LICENSING TOPICAL REPORT

# ASSESSMENT OF REACTOR INTERNAL VIBRATION IN BWR/4 AND BWR/5 PLANTS

SUBJECT: ACCEPTANCE FOR REFERENCING TOPICAL REPORT NEDE-24057 P  
ASSESSMENT OF REACTOR INTERNALS VIBRATION IN BWR/4 AND  
BWR/5 PLANTS

Figure 4-2. Strain Gage Location on Feedwater Spargers at Brunswick 1.

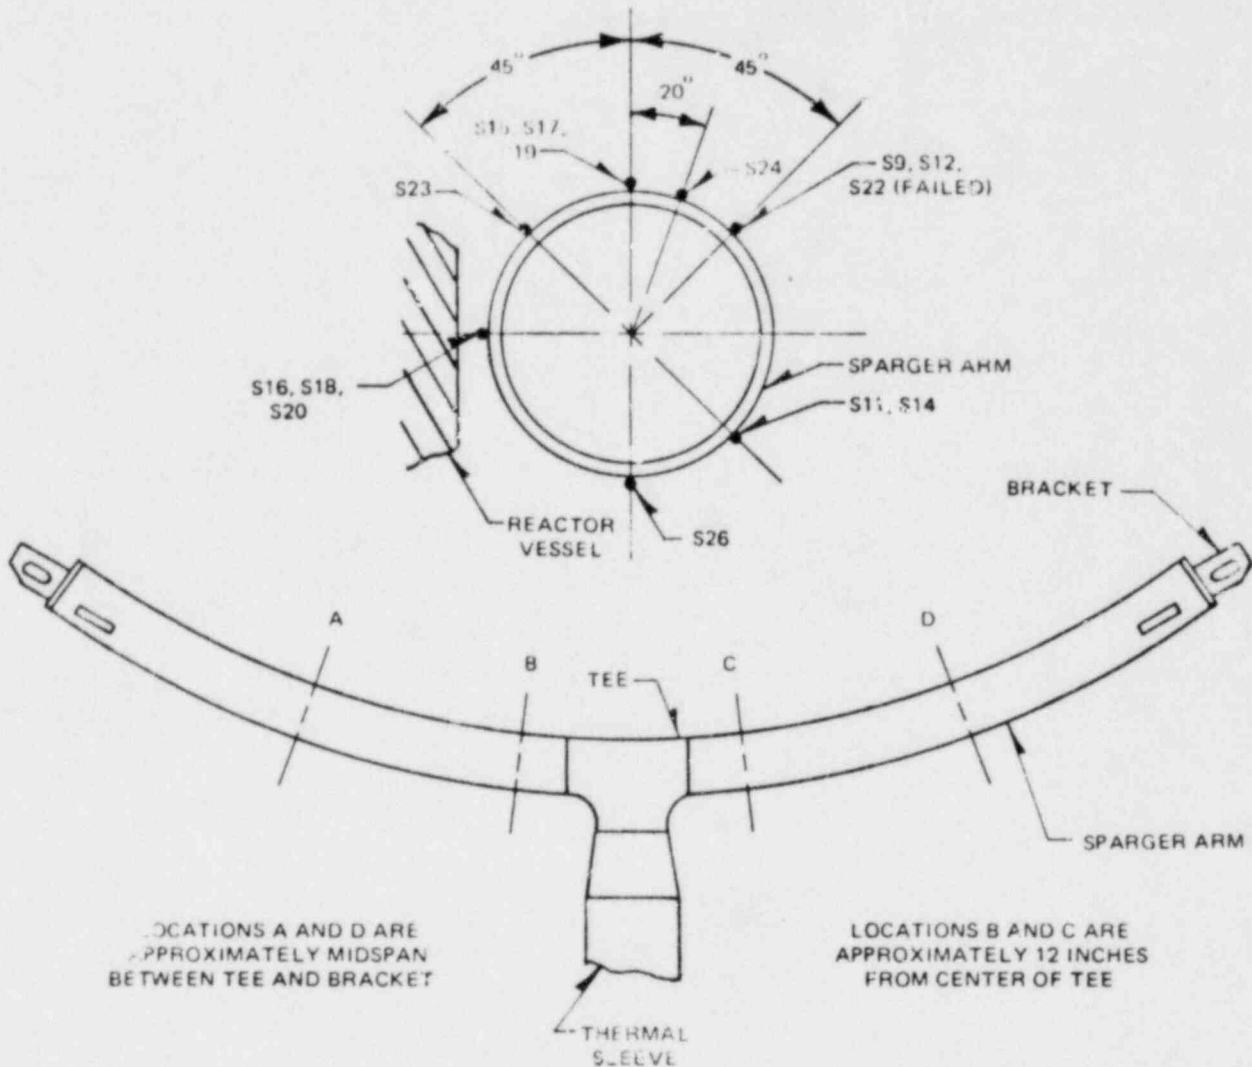
Supplement section 4.2 and Figure 4-2 by providing azimuth orientation of the shroud barrel in order to clarify the strain gage locations in the Brunswick 1 spargers.

All azimuth coordinates are with reference to shroud head guide rods (Figure 4-8) and lower plenum access openings (Figures 4-12 and 4-13) at zero and 180°.

Figure 4-3. Strain Gage Locations on Incore Instrument Tubes at Browns Ferry 3.

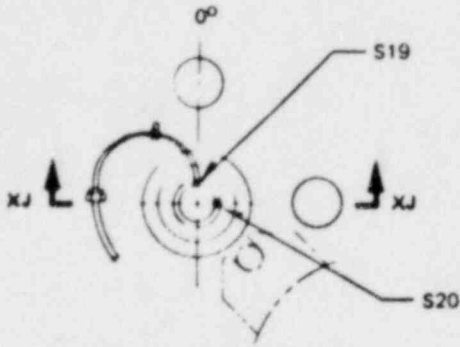
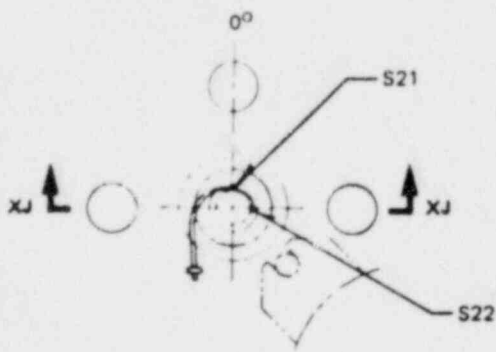
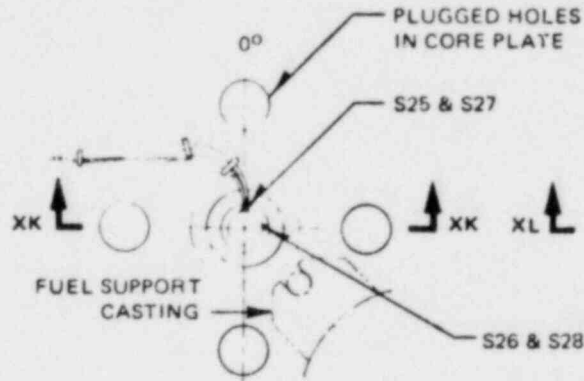
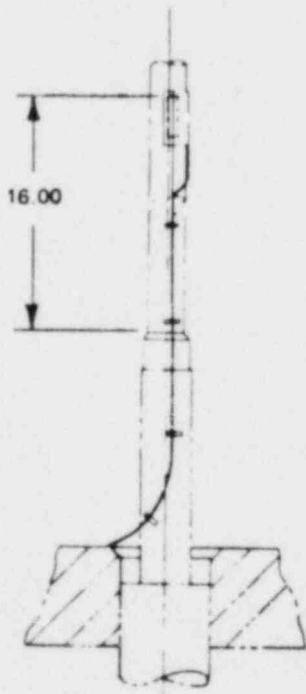
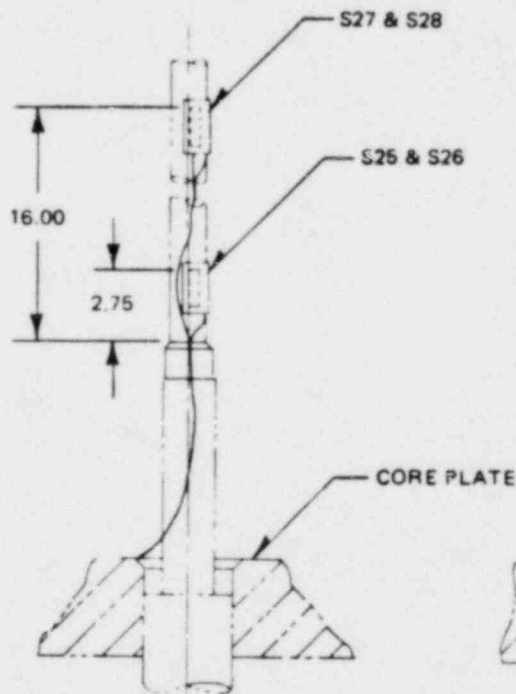
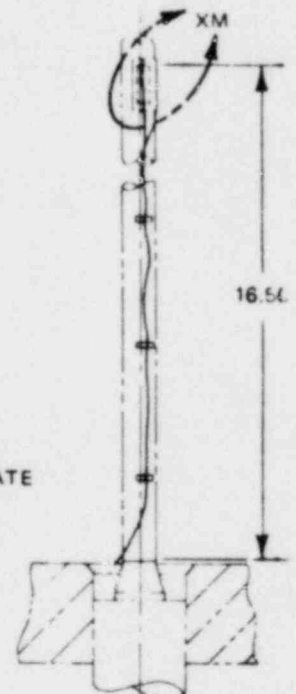
Supplement Figure 4-3 by providing an additional drawing which identifies the relative locations of the in-core instrument tubes and fuel channels in the core plate.

Figure 4-10. Accelerometer Locations on In-Core Instrument Tubes at Browns Ferry 3. Parentheses denote reactor hardware.

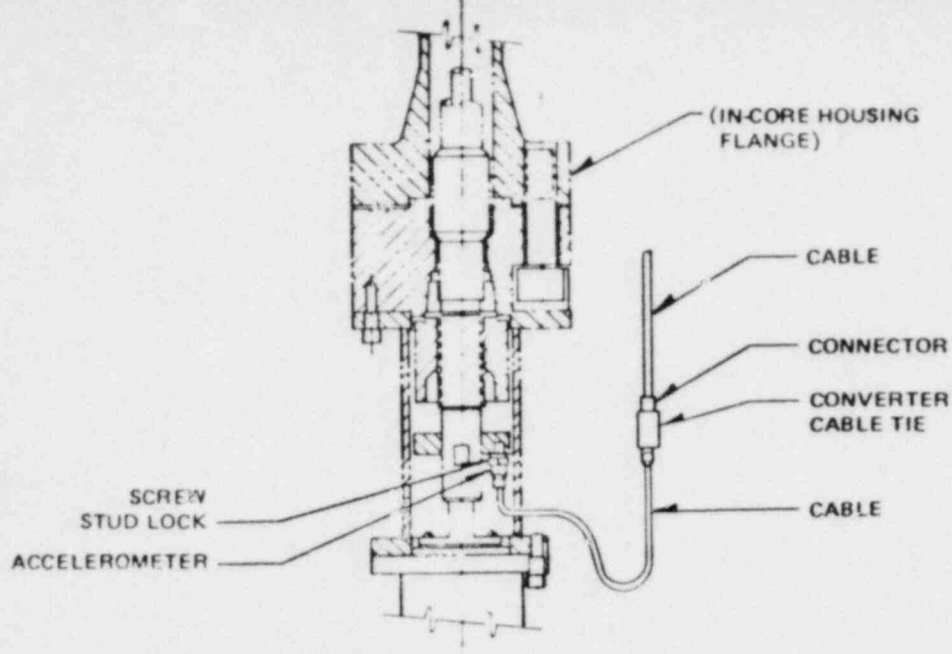
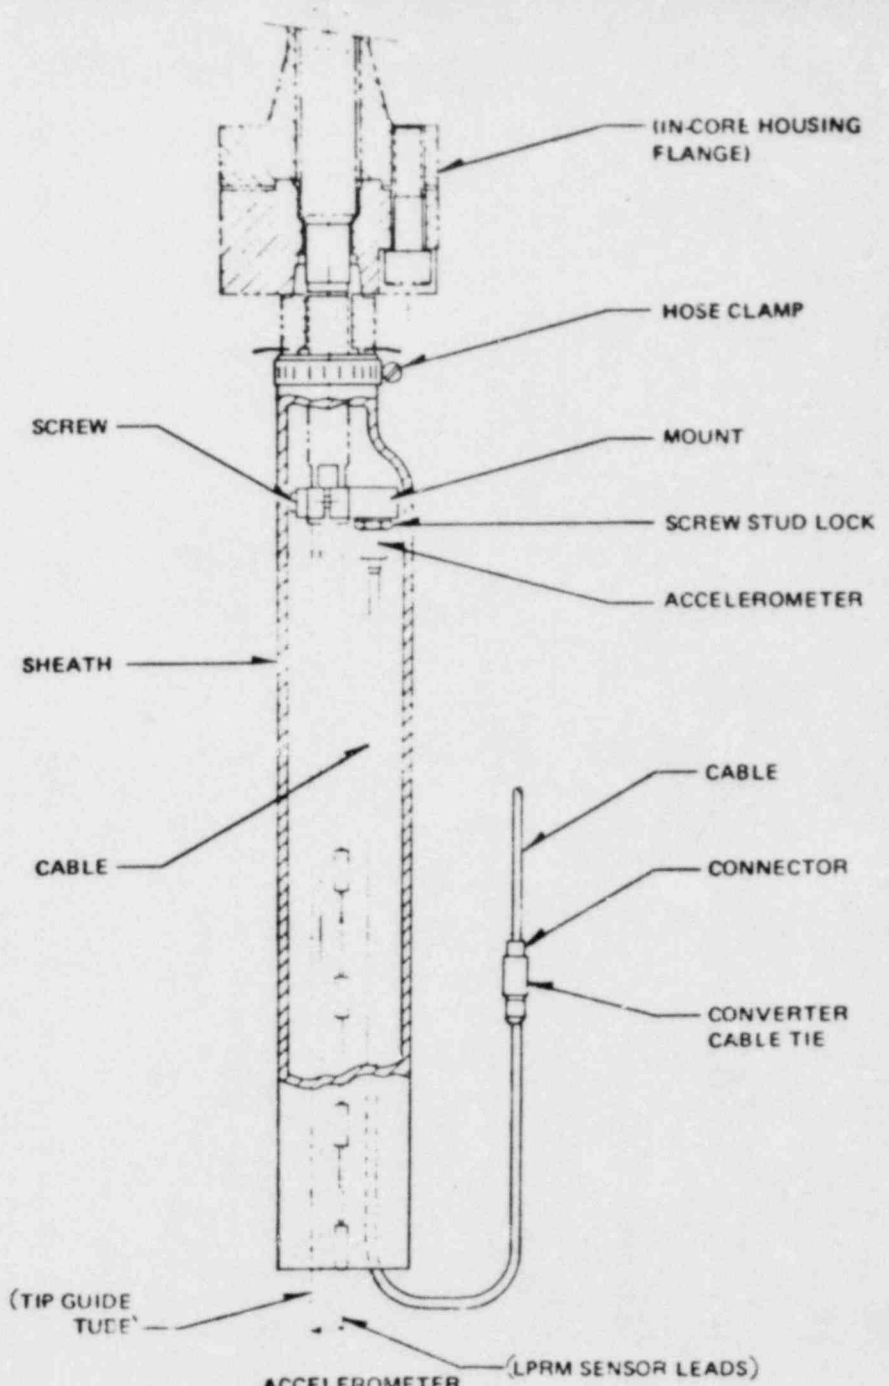
Supplement Figure 4-10 by providing the following:

- a. Seven LPRM tubes and one IRM tube was instrumented. The coordinates of these eight tubes as shown on Figure 4-10 may be identified on Figure H and Figure I show the relative locations.
- b. The purpose of the instrumentation is to verify the basic design configuration consisting of an in-core instrument tube subject to bypass leakage flow. Eight tubes were instrumented to evaluate possible local variations in flow or in assembly tolerances, and to provide some redundancy to accommodate possible sensor failures. Instrument locations were chosen to provide some sensors near the periphery of the core and some sensors nearer to the center of the core.
